Product/Process Change Notice (PCN)

PCN #: PCN_WE-STAR-TEC_20151207_74271132(S)_Capacity Increase

Product Affected: 74271132, 74271132S

Already established production line of plastic housing:

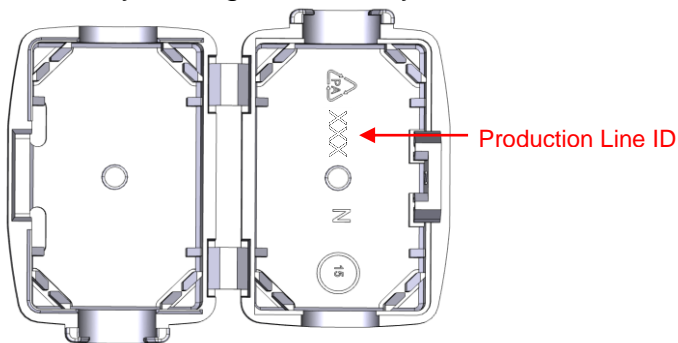
1. Neither electrical nor mechanical properties of the part will be changed.
2. The production lines can be identified by the three digits inside the plastic housing.

Digits: 128

Country of Origin: Germany

Additional production line of plastic housing:

Digits: 375

Country of Origin: Germany
